**Re: Further Site Investigation Request Response  
Former Union Street Sunoco  
1126 South Union Street  
Mishawaka, Indiana  
FID #: 9672  
LUST #: 199401501**

Quality Environmental Professionals, Inc (Qepi) is pleased to respond to the Indiana Department of Environmental Management's (IDEM) review letter of the *Further Site Investigation* submitted May 12, 2008 for the above-referenced site. Qepi has prepared the following responses to comments outlined in the January 14, 2009 letter. IDEM's further site investigation (FSI) request letter is provided as Attachment A.

FIGURE 1  
 SITE MAP  
 FORMER UNION STREET SUNOCO  
 1126 SOUTH UNION STREET  
 MISHAWAKA, INDIANA

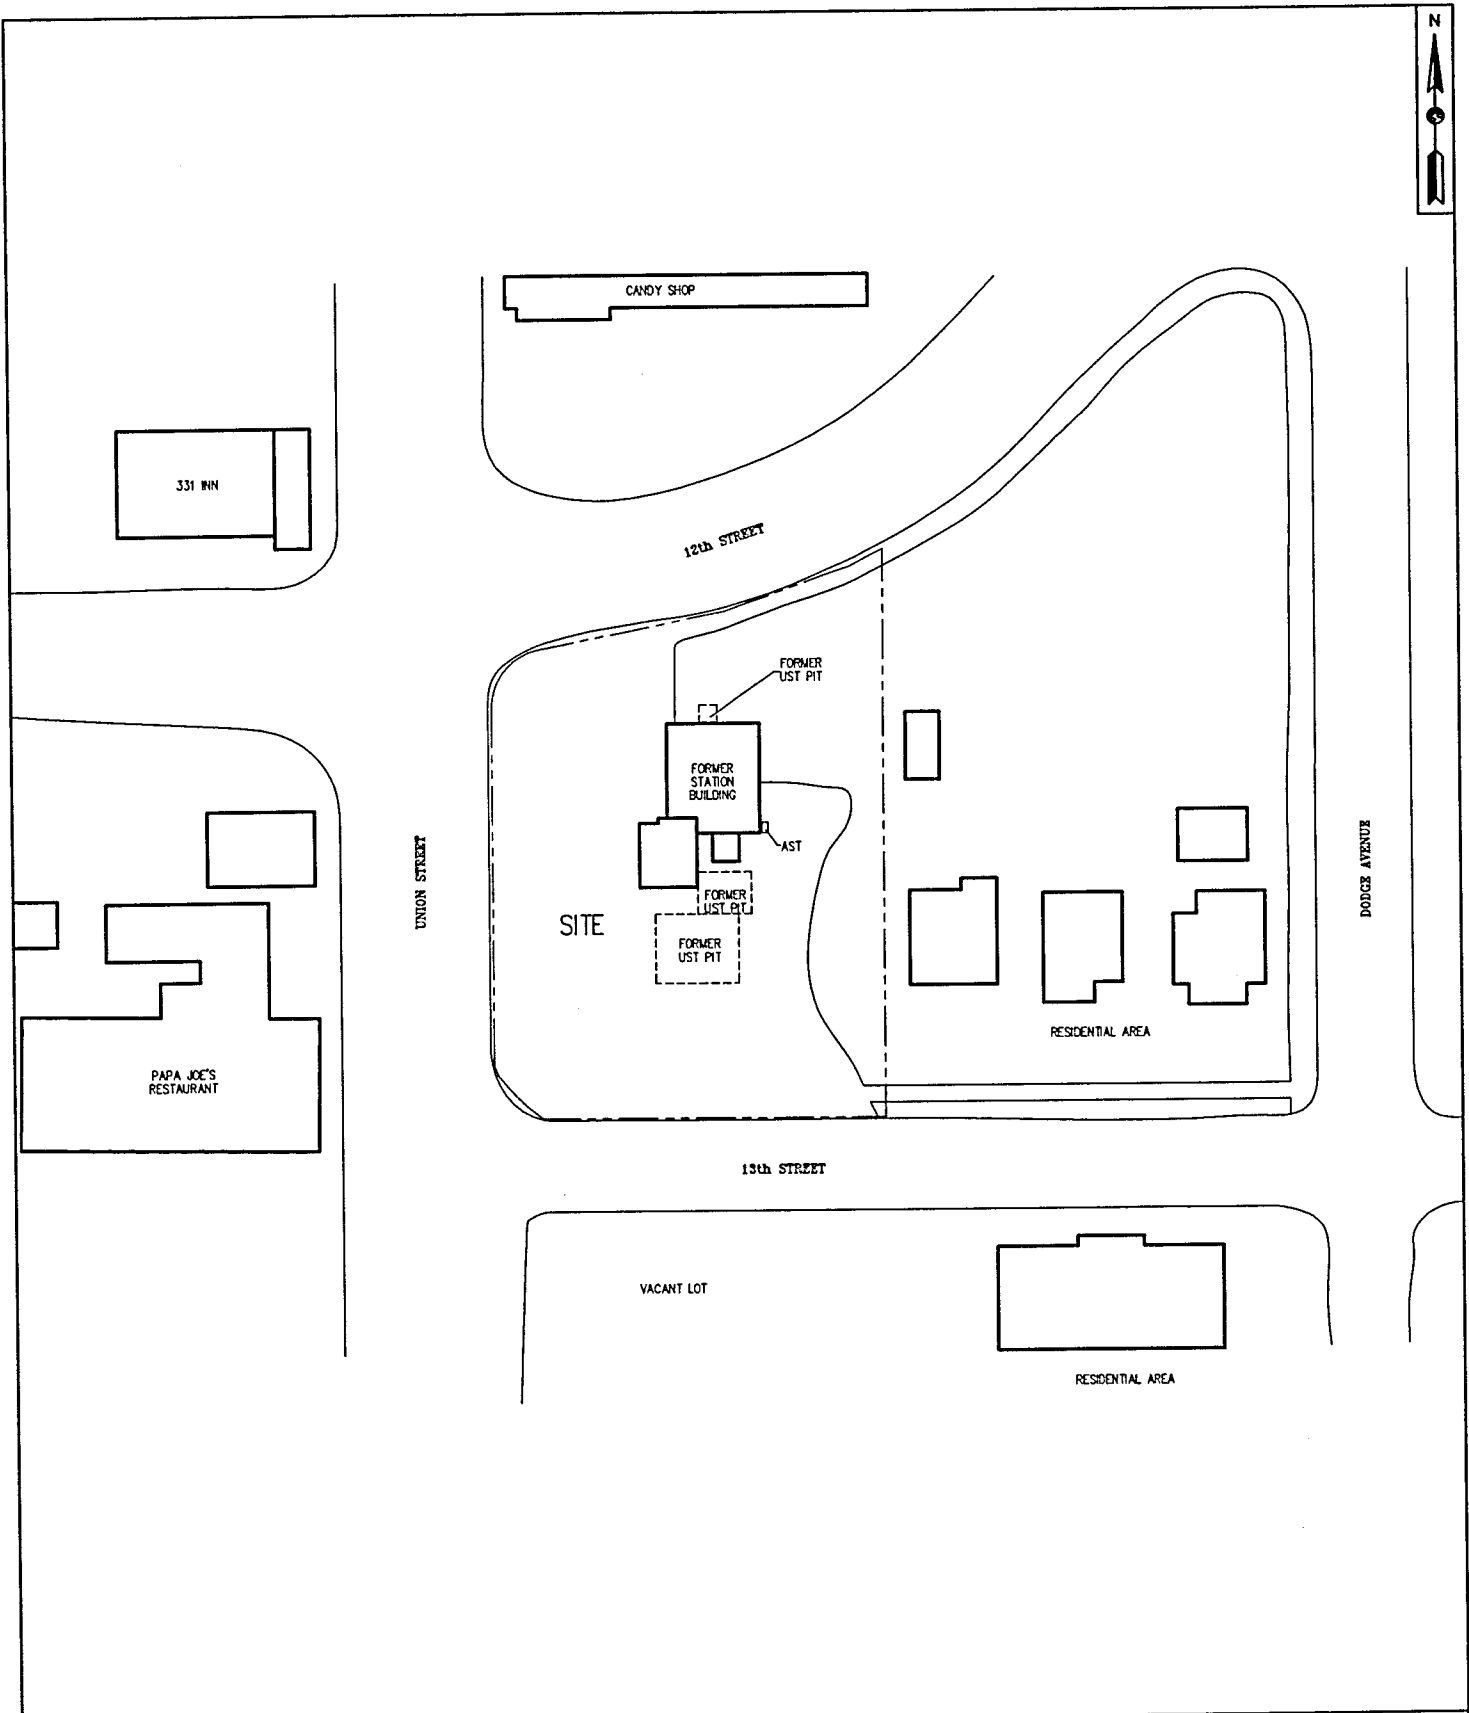
- ***“The report references three UST tank pit locations, but only depicts one in all of the figures. The UST tank pit area does not have borders. All UST tank pit area must be depicted in future reports with well-defined boundaries. Please include all former UST***

***tank pit locations on site maps in the FSI report. Additionally, the location of the former dispenser island should be located on all site maps in the FSI report.”***

Future reports provided to IDEM will include these locations, as requested. This updated site figure has been included in this response letter as Figure 1.
